ADDENDUM NO. 3 ISSUED BY

ABHA Architects 1621 N. Lincoln Street Wilmington, Delaware 19806

ADDITIONS AND RENOVATIONS TO: BRANDYWINE SCHOOL DISTRICT TRANSPORTATION CENTER PROJECT NO. 1228

<u>DRAWING E-111, "ELECTRICAL – LIGHTING NEW WORK"</u> At Drawing E1/E-111:

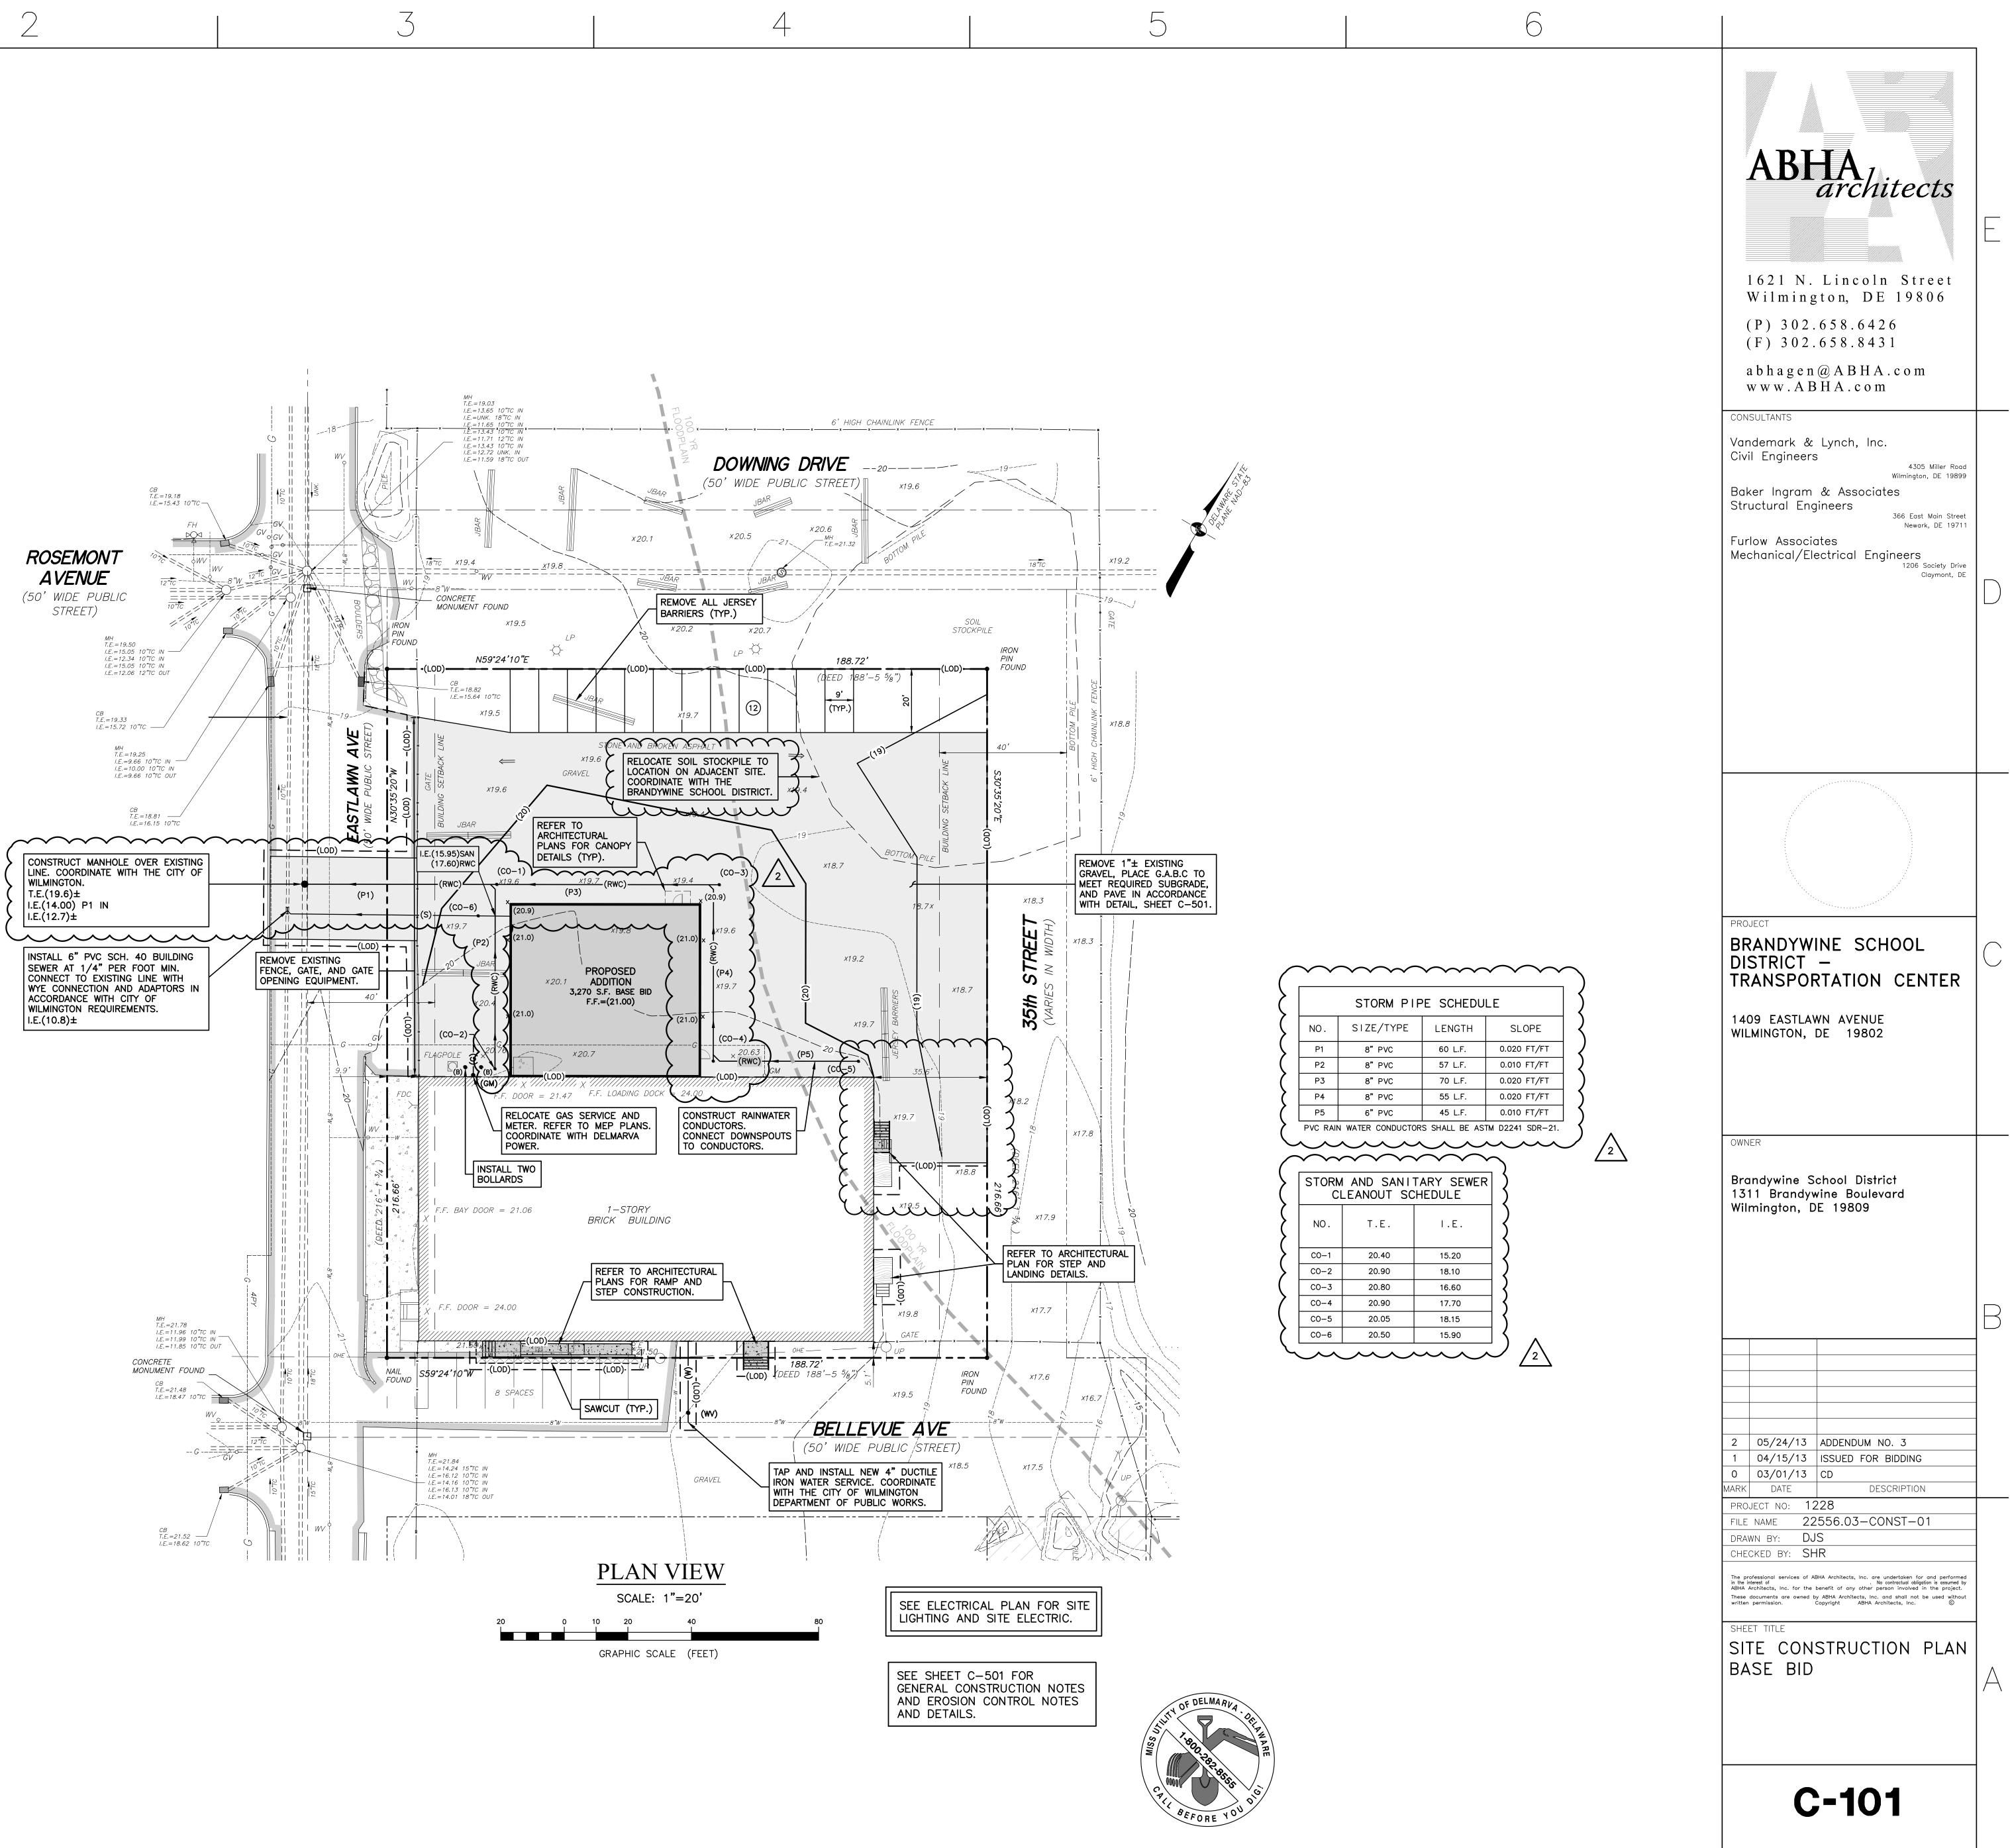
a. At <u>Vestibule 118:</u> Tag fixture as Type "A2."

b. At <u>Vestibule 111:</u> ADD Type "E", Exit Sign above door.

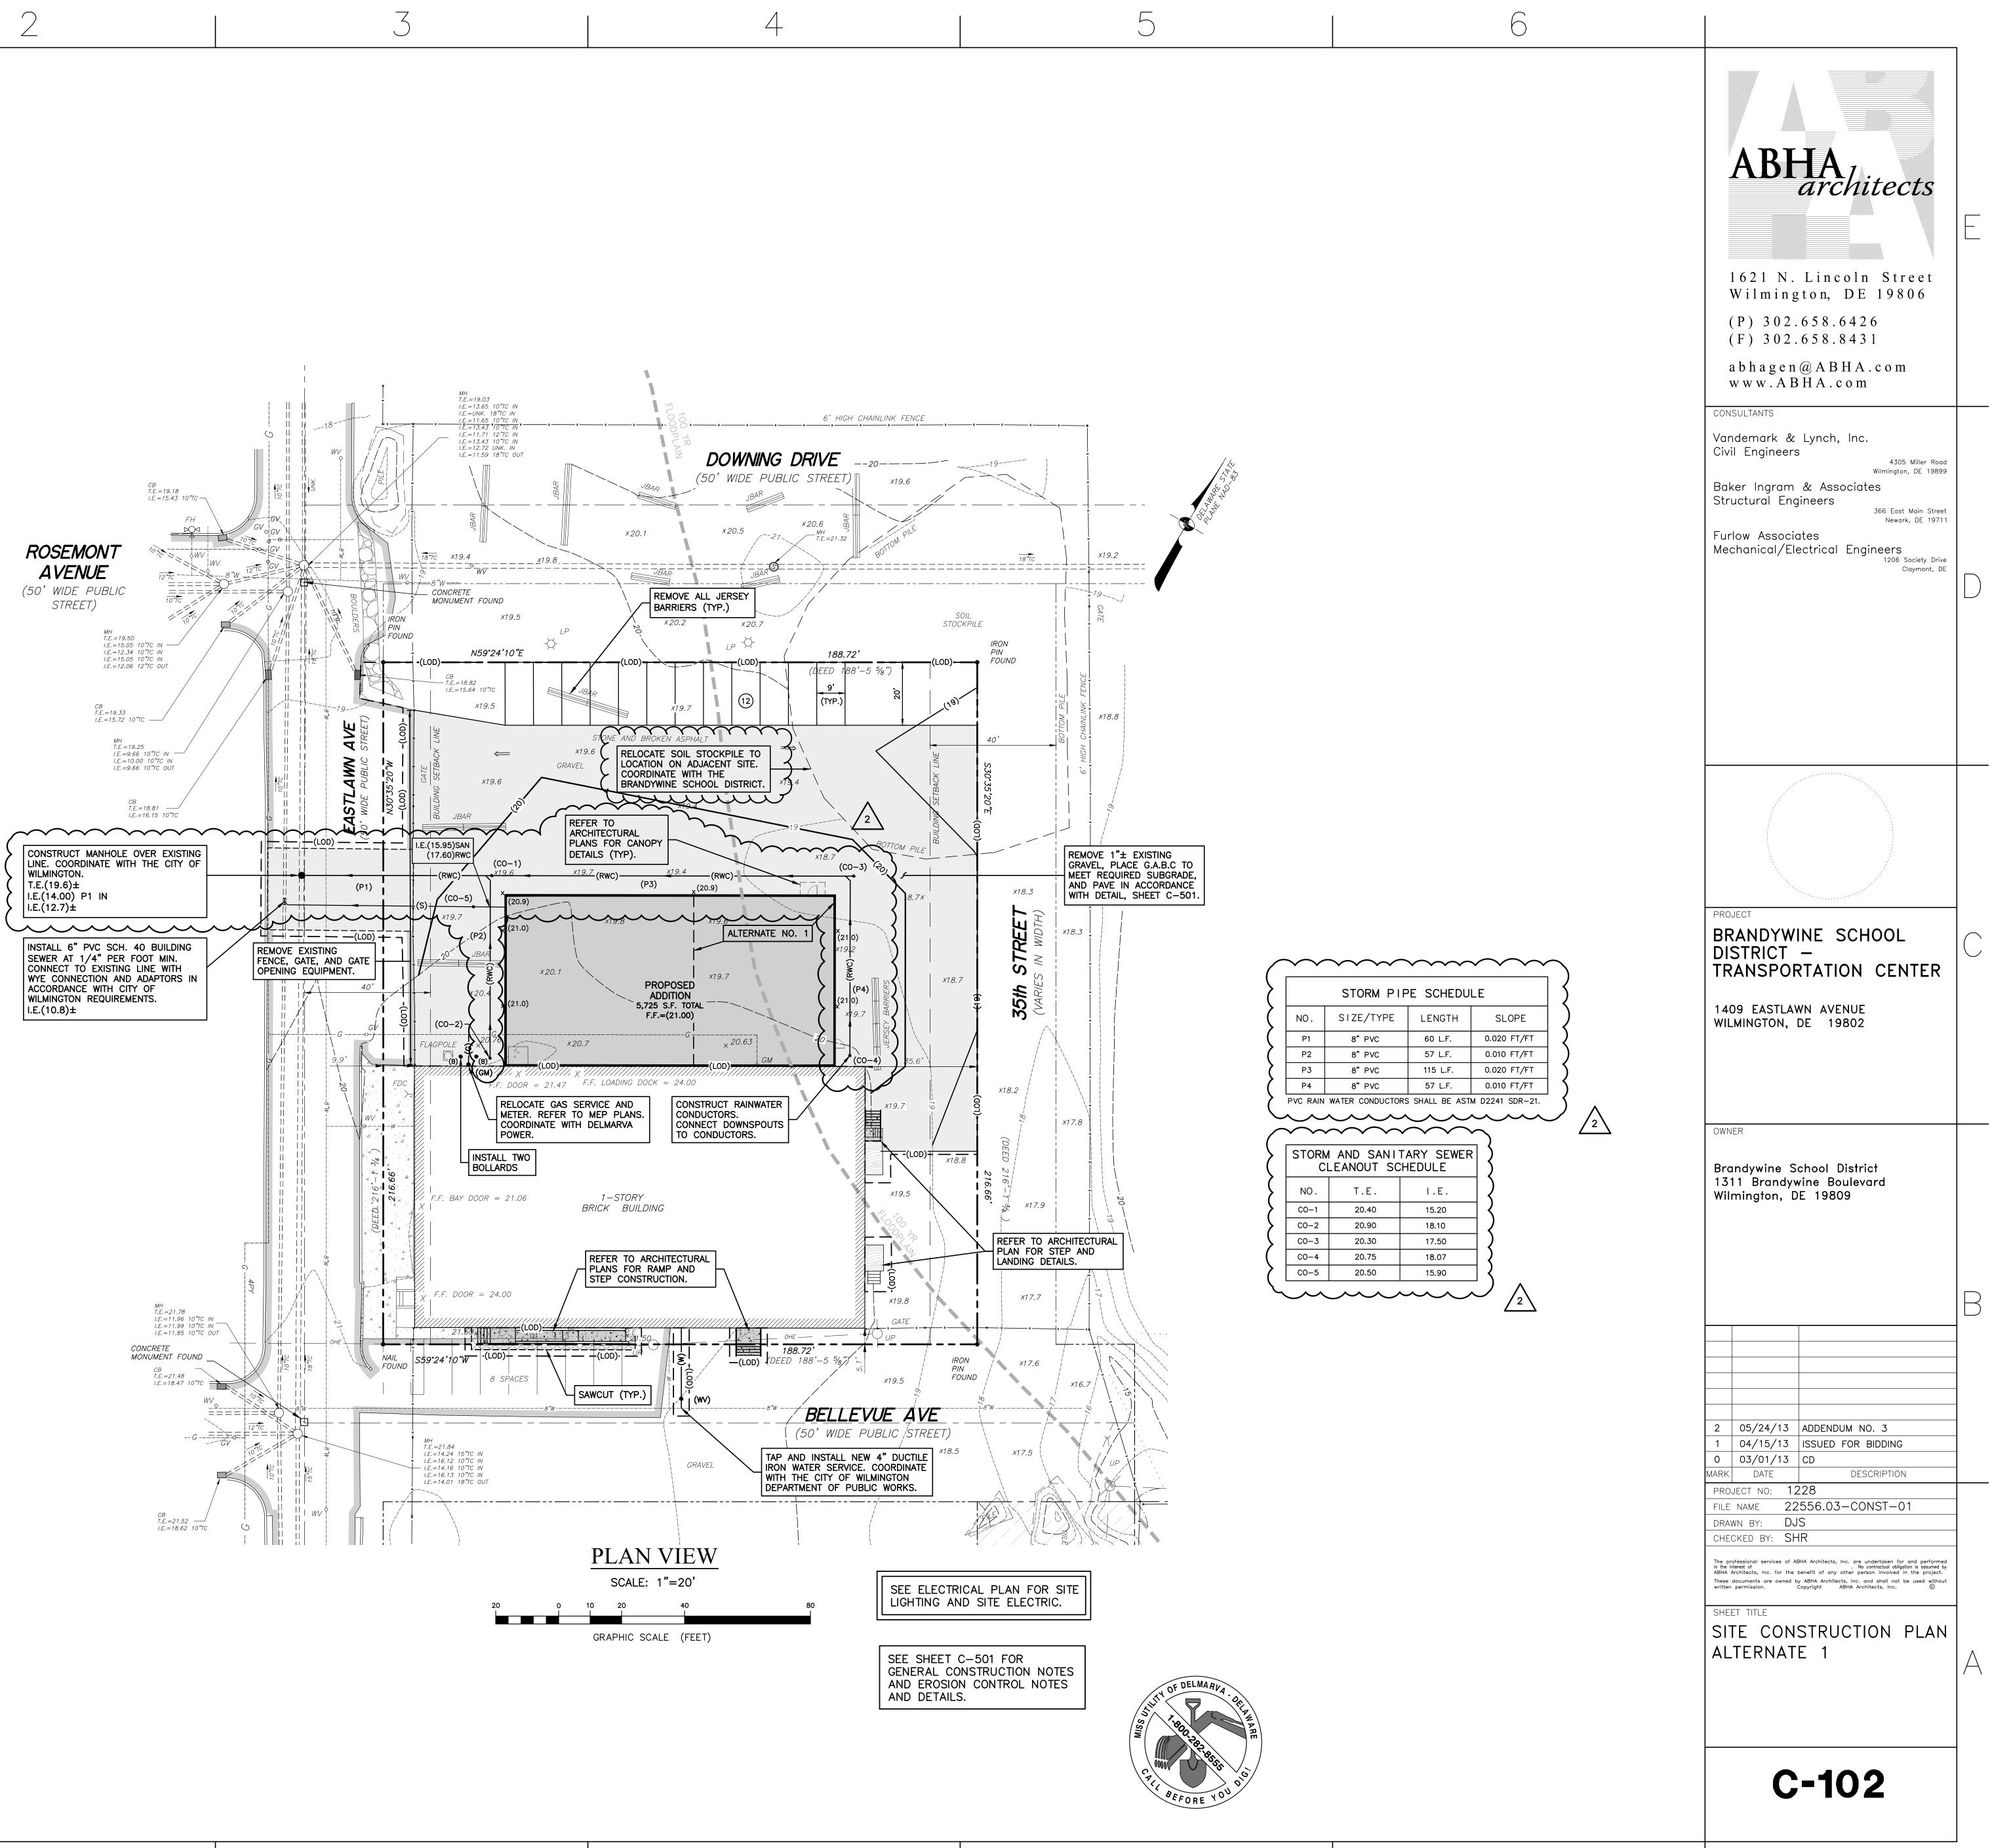
- Q5. Do the 12 parking spaces on the north side of the parking lot shown on sheet C-101 get hot mix paving? Area is not shaded like the rest of the paving.
- A5. No. Parking has been designated to meet City of Wilmington zoning requirements. No paving is required for these (12) spaces.
- Q6. Are CCR reports required? If so, will they be provided by the owner?
- A6. No. Owner will provide CCR reports if required.
- Q7. Drawing C-100 does not show any silt fence or temporary fencing. Please provide a layout if required.
- A7. Silt fencing is not required, except for silt fencing around soil stockpiles in accordance with DNREC requirements and the "Contaminated Materials and Water Management Work Plan" issued with Addendum No 1.

Delete Drawings C-101, C-102, and C-501, and replace with revised Drawings C-101, C-102, and C-501 attached to this Addendum.
